CONSTRUCTION AND ENVIRONMENTAL MANAGEMENT PLAN (CEMP) REVISION 006

EXPLANATORY NOTE

Project: Laois Kilkenny Electricity Reinforcement Project – Unit 1: A new 400kV/110kV Substation at Coolnabackey townland, Co. Laois.

Figure 8: North- South Cross Section detailing existing Structures and Oil Separator

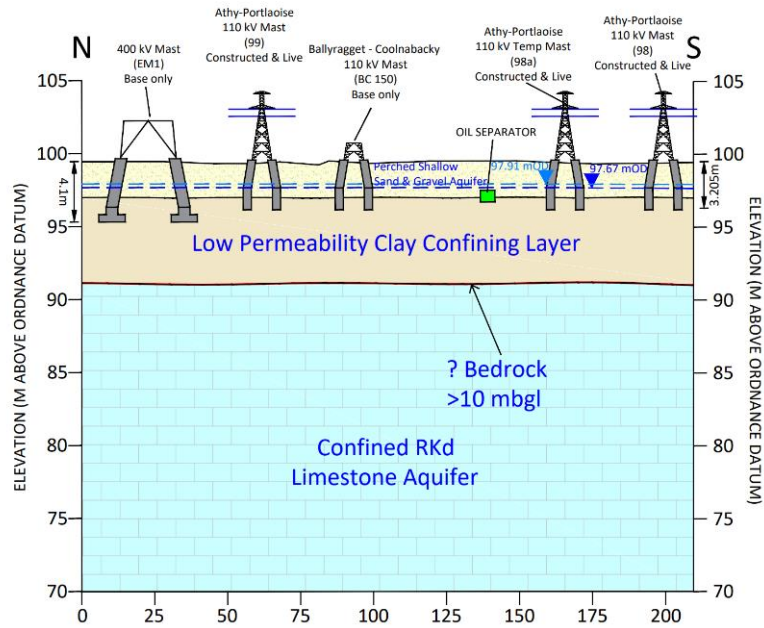
Amendment note 2: Inserted Figure 8.

"Figures 6, 7 and 8 show the cross sections illustrating the latest understanding of potential interaction between infrastructure units and the shallow aquifer"

Figure 11: Extract from Compound Drainage Layout PE493-D108-125-002-005 showing all Full Retention Oil Separators within the substation compound

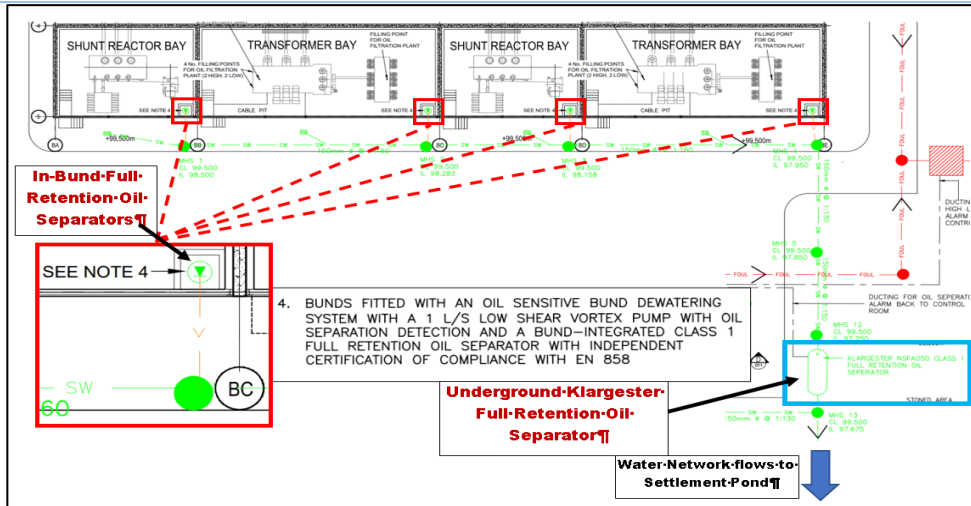
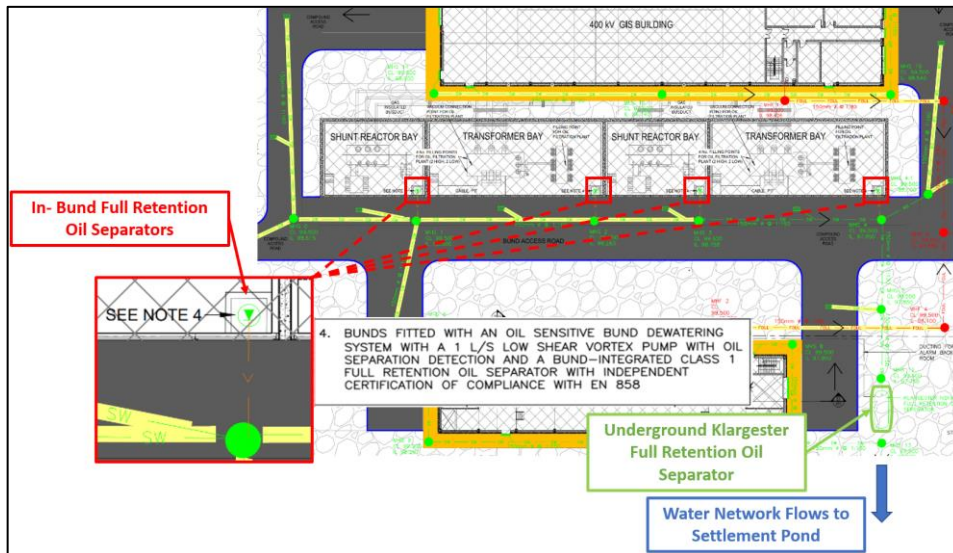
Amendment note 3:	Replace Image, updated caption as underlined
The Following Figure:

CEMP Section:	4.1.6.3 Klargester Full Retention Oil Separator
Amended to include:	Contents of Supplementary information provided in response to Independent Risk Assessment, submitted by ESB on 7 th January 2024, relating to the drainage network served by the oil separator at the Coolnabacky Site.
Amendment note 1:	Updated Text as underlined
<p>The Paragraph in Section 4.1.6.3 which reads:</p> <p><u>“The area of the substation compound which will hold oil filled equipment (transformer bunds, impermeable access routes etc) will be linked to an underground drainage network which will drain to the underground Klargester oil separator. Water from the oil separator will discharge to settlement pond no. 2, located to the south of the site.”</u></p> <p>Is replaced with:</p> <p><u>“All impermeable areas of the substation compound access roads will be linked to an underground drainage network which will drain to the underground Klargester oil separator. Water from the oil separator will discharge to settlement pond no. 2, located to the south of the site as shown in Appendix 6 – Compound Drawing No. PE493-D108-125-002-005. The design also includes kerbing around all compound access roads, which will be cambered sufficiently to direct stormwater toward the underground separator drainage gulleys.”</u></p>

Amendment note 2:	Updated Text as underlined
<p>The Paragraph in Section 4.1.6.3 which reads:</p> <p><u>“This Section (Section 4.1.6.3) refers to the underground Class 1 full retention oil separator. The oil separator will function during the operational phase of the substation but will be installed during the construction phase. The full retention oil separator is designed to serve the bund dewatering systems from the transformer bunds and the impermeable surface areas surrounding the bunds and access road.”</u></p> <p>Is replaced with:</p> <p><u>“This Section (Section 4.1.6.3) refers to the underground Class 1 full retention oil separator. The oil separator will function during the operational phase of the substation but will be installed during the construction phase. The full retention oil separator is designed to serve the bund dewatering systems from the transformer bunds and the impermeable surface areas <u>of the substation compound access roads.</u>”</u></p>

Figure 16: Waste Control Area

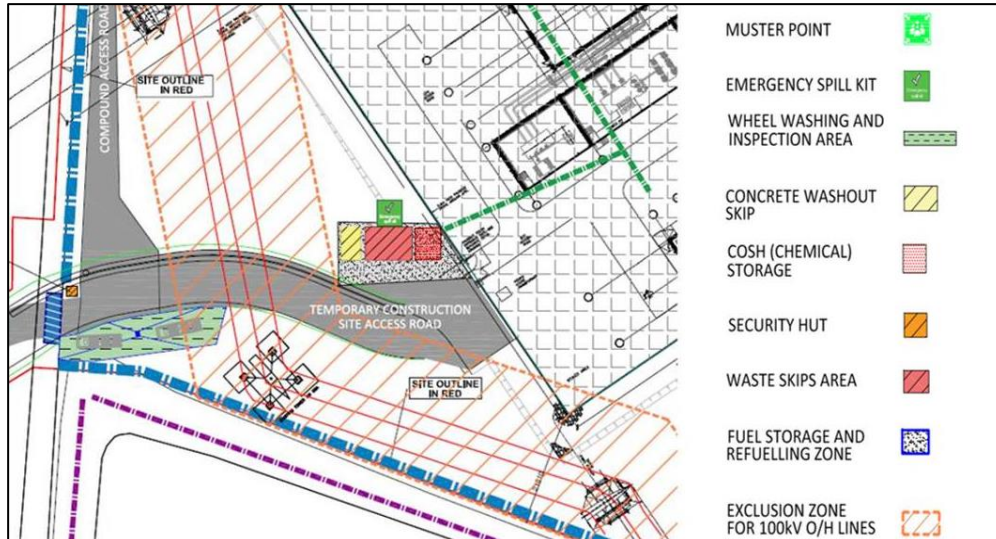
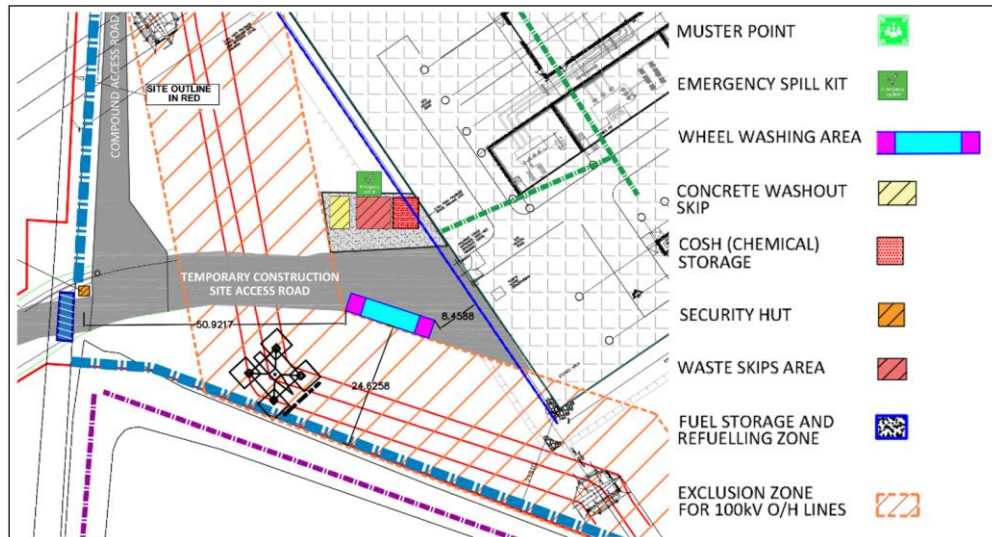
CEMP Section:	5.8 Waste Management
Amended to include:	Contents of Response to CEMP RFI submitted by ESB on 16th November 2023, Item No. 1. "Vehicle Wheel Wash Area"
Amendment note:	Replace Image

The Wheel wash area as depicted in Appendix 2.- Site Logistics Plan maintains a minimum of 5m distance from any adjoining surface water land drain or watercourse and is located outside of the overhead line exclusion zone in the vicinity.
